RETREAT AT TIMBERRIDGE FILING NO. 3

COUNTY OF EL PASO, STATE OF COLORADO

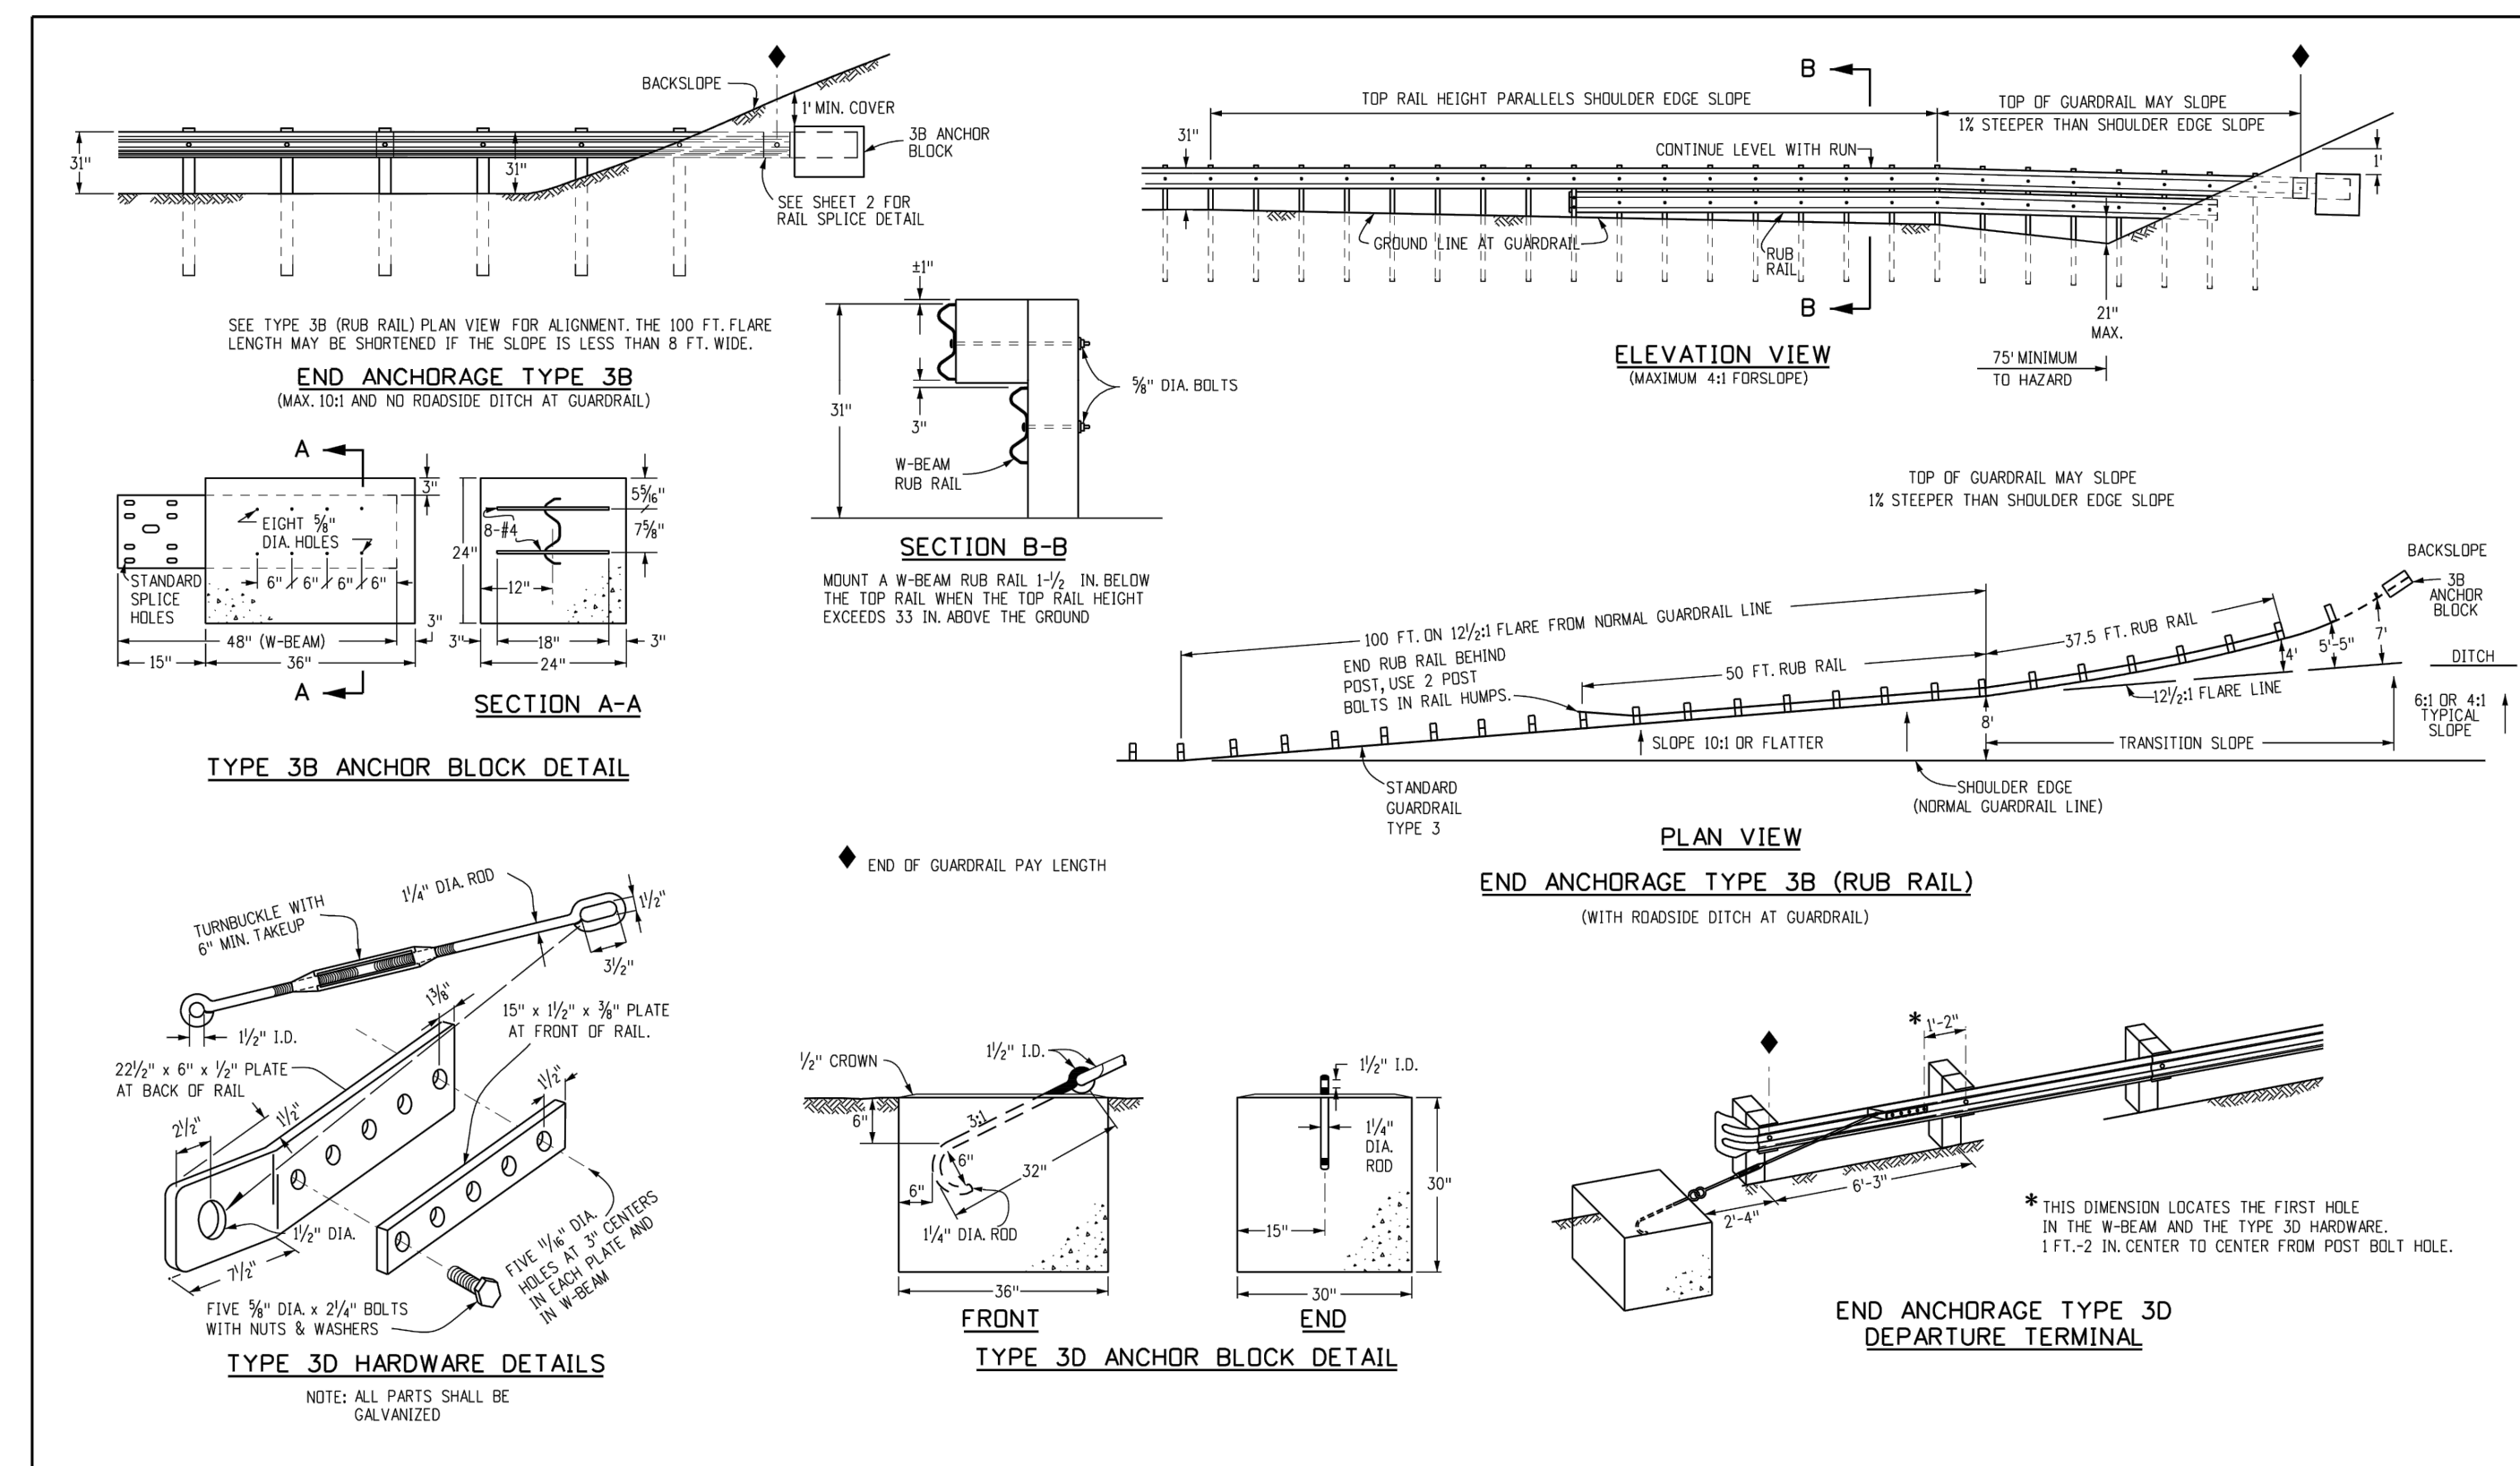
Computer File Information	Sheet Revisions	Colorado Department of Transportation	MIDWEST GUARDRAIL SYSTEM (MGS) TYPE 3 W-BEAM 31 INCHES	STANDARD PLAN NO. M-606-1
Creation Date: 07/31/19 Designer Initials: JBR Last Modification Date: 03/05/20 Detailer Initials: LTA CAD Ver.: MicroStation V8 Scale: Not to Scale Units: English	Date: 03/05/20 Comments: Revised per Note 1 to show MASH compliant	2829 West Howard Place CDOT HQ, 3rd Floor Denver, CO 80204 Phone: 303-757-9021 FAX: 303-757-9868	Issued by the Project Development Branch: July 31, 2019	Project Sheet Number:
